Product / Process Change Notification (PCN)

PCN #: PCN_conWTB125_20231220

Affected Series: WR-WTB125 6531xx131822

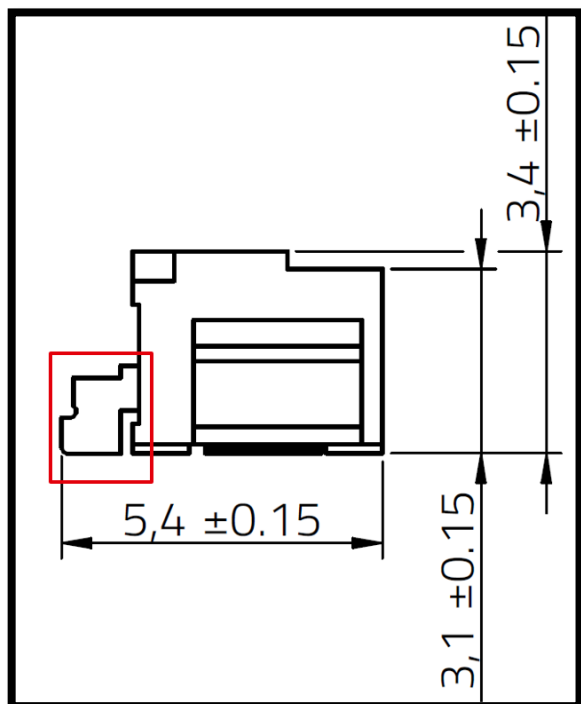
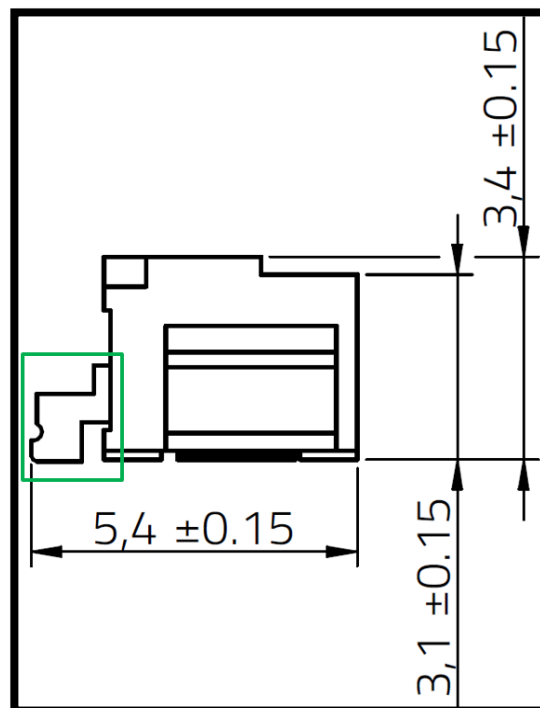
The shape of the pin on the WE Datasheet is incorrect in comparison with the physical part and should be corrected:

As a Datasheet information amendment, Würth Elektronik will correct the drawing of the datasheet for the series: 6531xx131822.
